# City of Portland, Maine - Building or Use Permit Application

Past Use: Vacant Land	Proposed Use: Single Family 28' x 42' w/ detached 22' x 22' garage	Permit Fee: \$890.00	Cost of Work: \$87,000.00	CEO District: 3
		FIRE DEPT: <input type="checkbox"/> Approved <input type="checkbox"/> Denied	INSPECTION: Use Group: R-3 Type: SF IRC 2003

**Dept:** Zoning      **Status:** Approved with Conditions      **Reviewer:** Ann Machado      **Approval Date:** 04/12/2007

**Dept:** Building      **Status:** Approved with Conditions      **Reviewer:** Chris Hanson      **Approval Date:** 05/14/2007

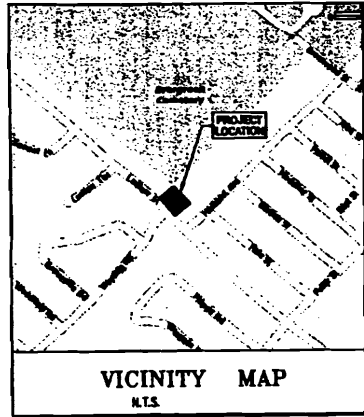
Thanks John. What is the exact distance between the building and the extension of the property line?

0.23 feet

## GRADING & UTILITY PLAN OF 287 LUDLOW STREET (LOT A) PORTLAND MAINE

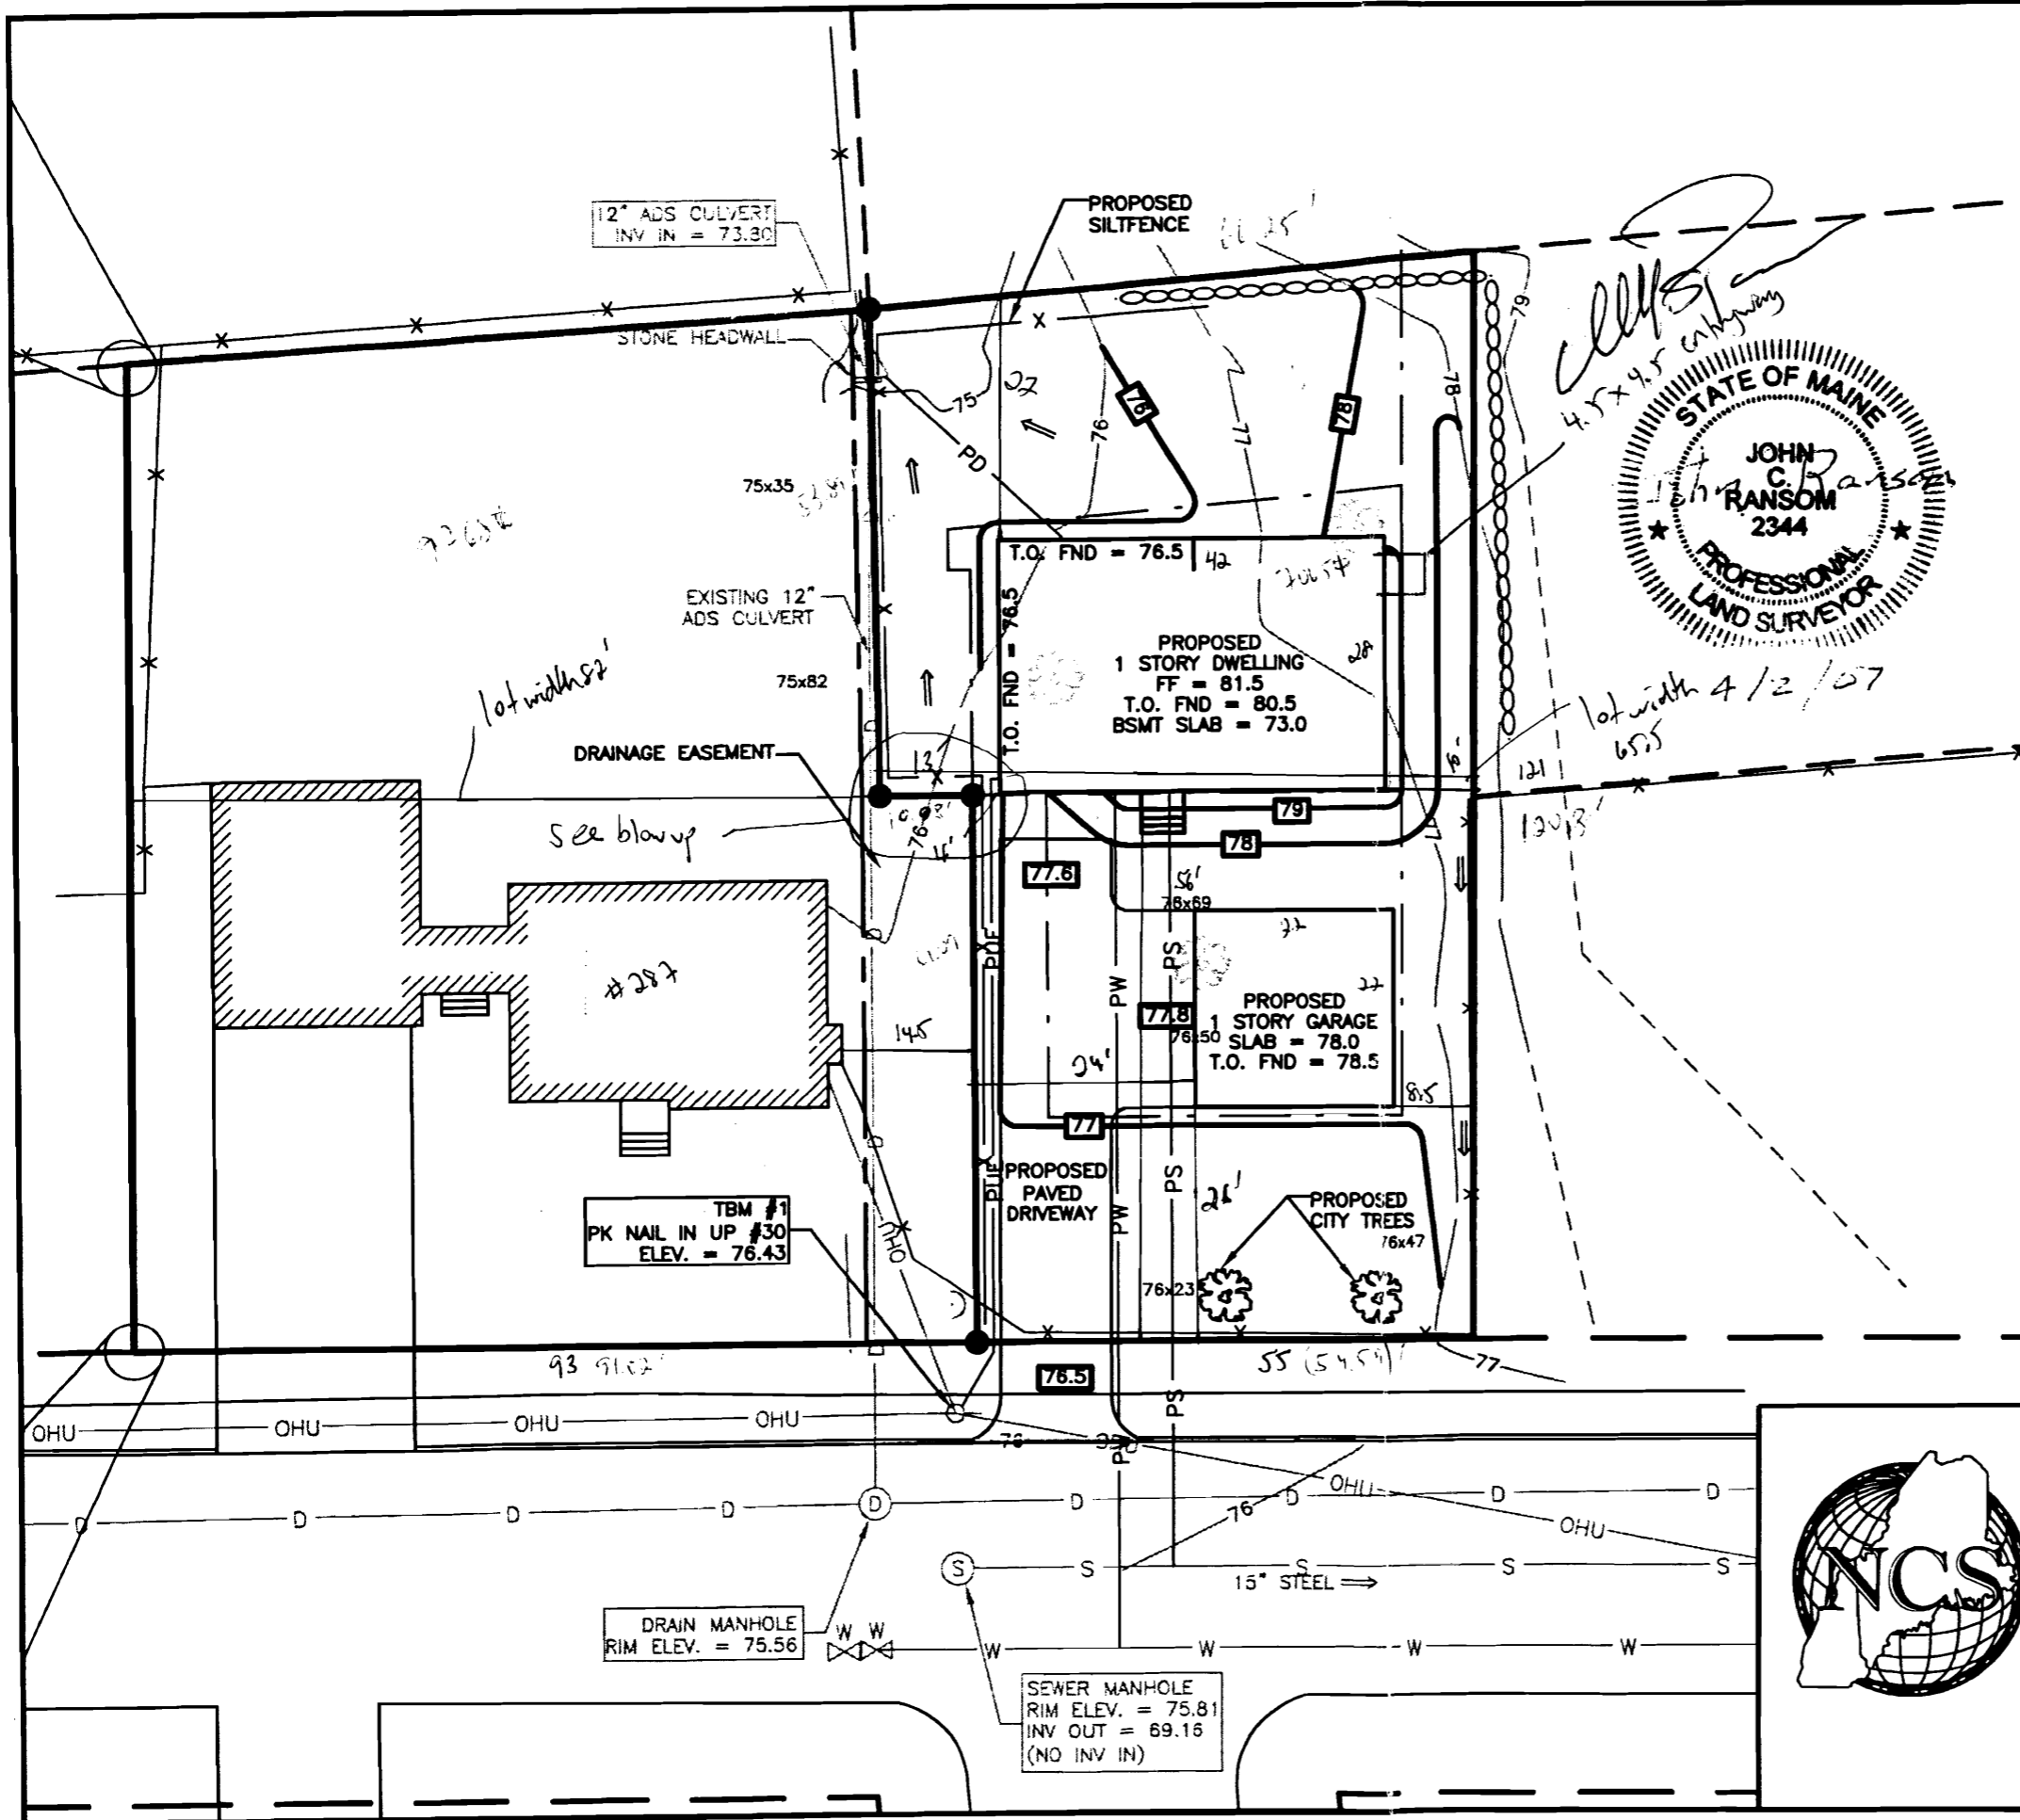
4/10/2007-amachado: Spoke to John Ransom at Northeast Civil Solutions. Need to know how far the front left corner of the house is from the side property line.

4/10/2007-amachado: Spoke to Mark Poirier. Need full size set of building plans. Need plans for garage. Site plan doesn't show the steps on the right side.

4/11/2007-amachado: Mark Poirier brought in full size plans. Put side entry on site plan. Still don't have plans for garage. Left messages with both Bob Swan and Mark Poirier.

I'm writing to certify that my survey crew visited the site this morning and shot in the corners of the foundations of both the house and the garage. We found that all the foundation corners are within the setback lines and within 0.1 feet of the positions shown on our plan titled "Grading and Utility Plan of 287 Ludlow Street Lot A Portland Maine" dated April 2, 2007.
